Appendix 2 MOD.613 - INTRODUCTION OF E.C.M.

1. This appendix contains information on the changes made to the pitch stabilizer system by the introduction of Mod.613. Descriptive and servicing details are

Fig. 1 Component location

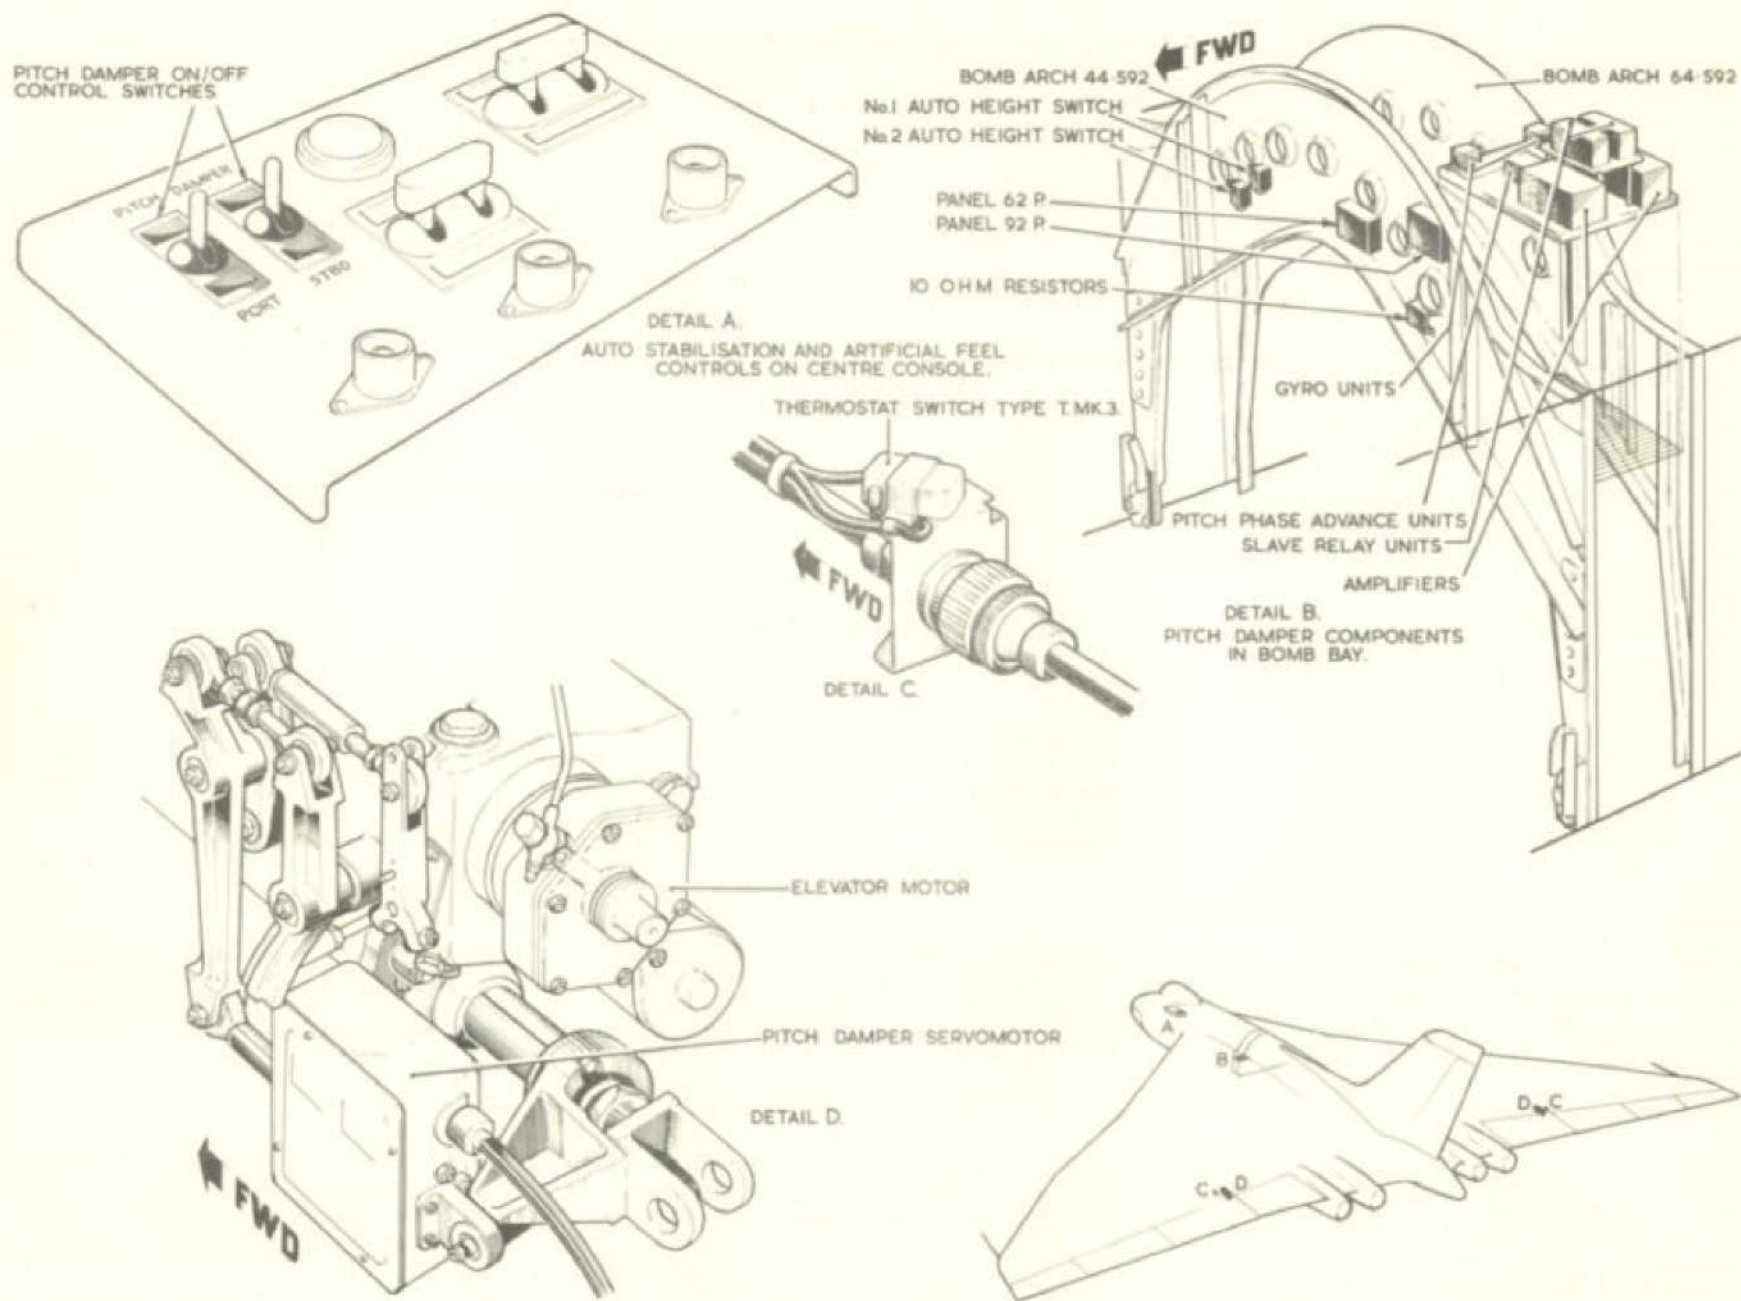
3. With the introduction of Mod.613 the two channels are made completely independent of each other. Two single-

pole switches replace the double-pole switch. An auto height switch is provided for each channel, and separate thermostats control the supplies to the servo heaters. A description of the new items and their effect on circuit operation is given in the paragraphs that follow.

4. These two switches, labelled PITCH DAMPER-PORT-STBD, are single-pole ON-OFF switches, Ref.No.5CW/6460. Each switch controls, by an associated relay, the d.c. supply to its associated pitch amplifier and at the same time provides a supply to the servo heater circuit. The switches are mounted on the retractable centre console, as shown in fig.1.

5. The two auto height switches are mounted on the forward face of bomb arch 44. Each switch is connected to the starboard pitot-static system and contains an aneroid capsule and relay. These items control, indirectly, a pair of relay contacts in circuit with the d.c. supply to their associated pitch amplifier. The switches thus prevent operation of the pitch stabilizer at altitudes below 20,000 ft. The switches are shown in fig.1 and fully described in A.P.1469S, sect.4, Chap.1.

6. The supply to the heater element of each servo unit, after leaving the control switch, is fed via a thermostat, Type 3 Mk.2. The thermostats, which are set to operate at temperatures of 0 deg.C and below, are mounted adjacent to their associated servo unit, as shown in fig.1.

7. This panel is introduced into the bomb-bay to house the additional relays introduced by Mod.613. The panel contains two relays, 707 and 708, which form part of the starboard pitch stabilizer circuit. The panel is shown in fig.1.

Fig. 2 Autostabilizer Power Supplies

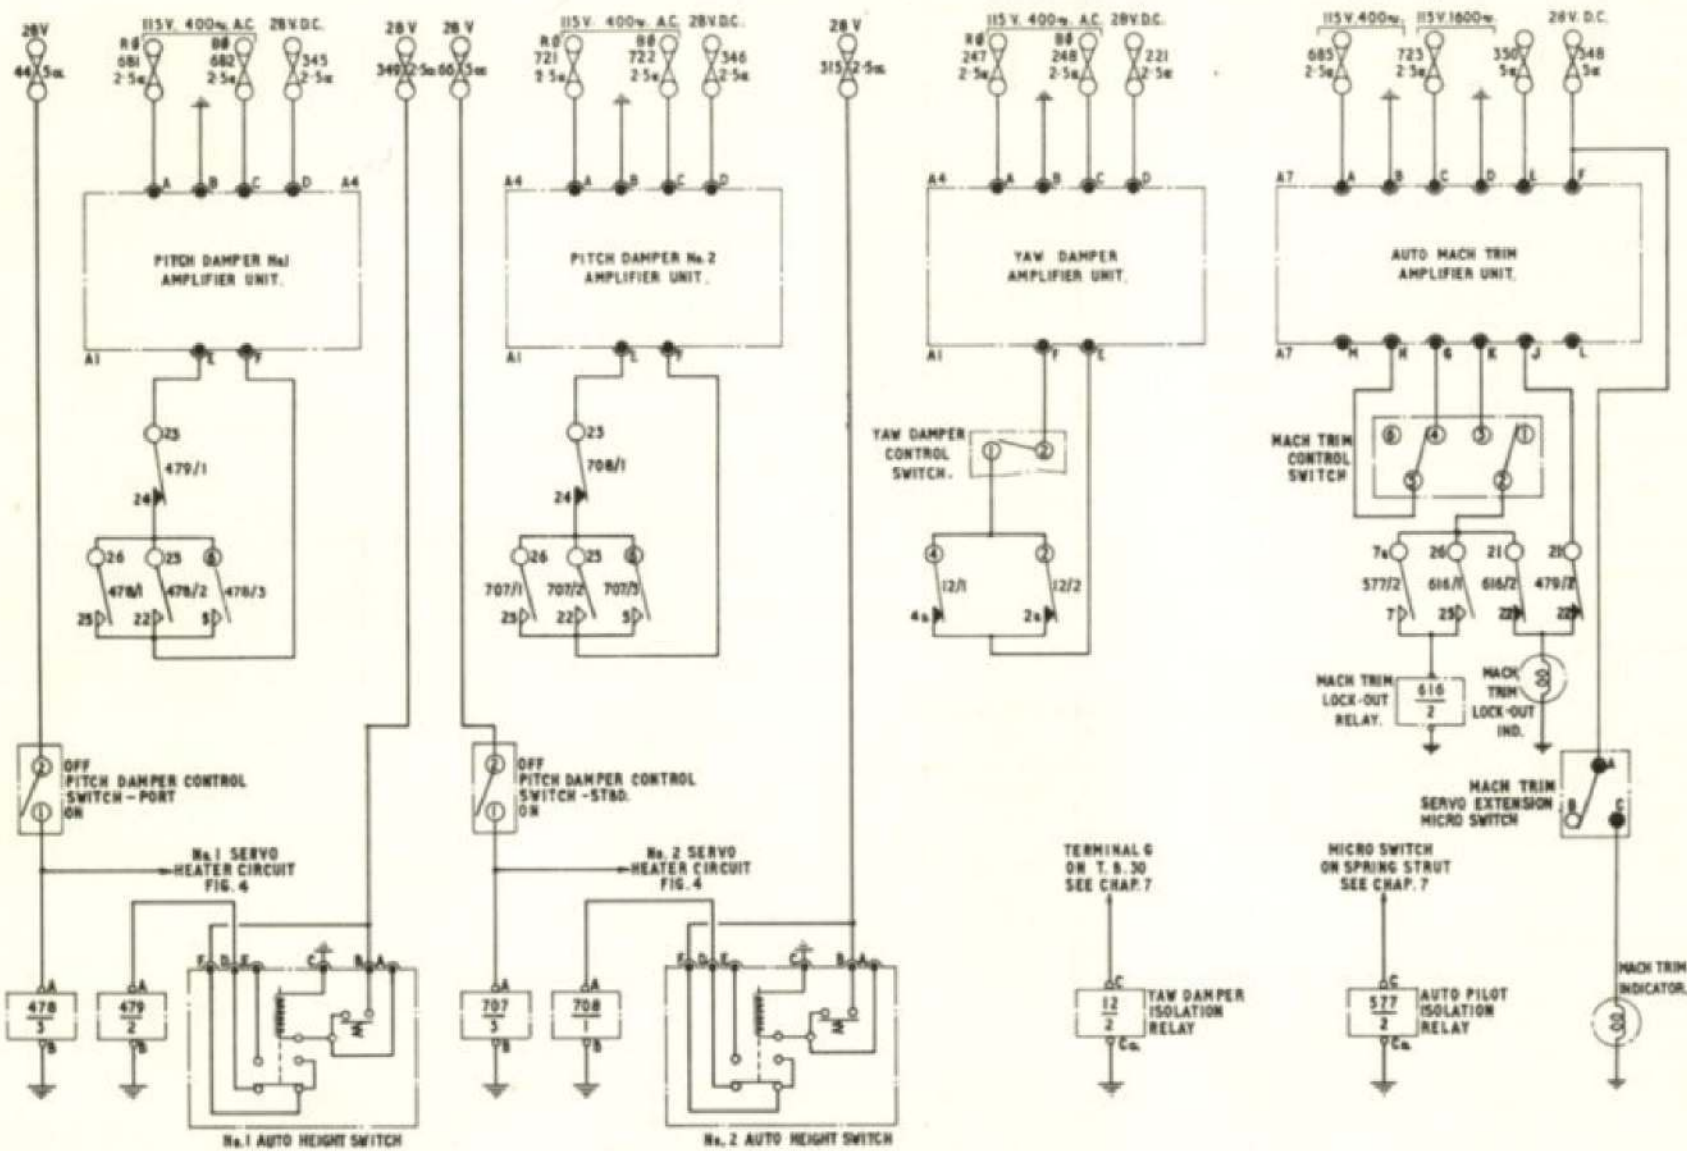
8. The power supplies to autostabilizer equipment are shown in fig.2 and it will be seen that the supplies to the mach

trim and yaw damper system are unchanged. Supplies to the pitch damper system have been changed to conform with the separate channel arrangement as follows:-

- 3P Fuse 44 - 28-volt d.c. to port channel control switch.
- Fuse 66 - 28-volt d.c. to starboard channel control switch.
- 16P Fuse 349 - 28-volt d.c. to auto-height switch No.1 (port)
- Fuse 315 - 28-volt d.c. to auto-height switch No.2 (starboard)
- Fuse 345 - 28-volt d.c. to No.1 (port) amplifier.
- Fuse 346 - 28-volt d.c. to No.2 (starboard) amplifier.
- 22P Fuse 681 - 115-volt, 400 c/s a.c. to 682 No.1 (port) amplifier from No.3 inverter
- Fuse 721 - 115-volt, 400 c/s a.c. to 722 No.2 (stb'd.) amplifier from No.1 inverter

10. Reference to fig.2 will show that selecting the port pitch damper control switch to ON will energise relay 478, thus closing relay contacts 478/1, 478/2 and 478/3. However, if the aircraft is below 20,000 ft. the system will be prevented from operating by the auto height switch.

At an altitude of 20,000 ft. or above, the internal contacts of the auto height switch will close to energise the internal relay. This will break the supply to relay 479, thus allowing relay contacts 479/1 to close and complete the d.c. circuit for the amplifier. The pitch damper system will now operate until either the ON-OFF switch is selected to OFF, or the aircraft altitude falls below 20,000 ft. Note that relay 479 still controls the mach trim system, as described in Group 7.
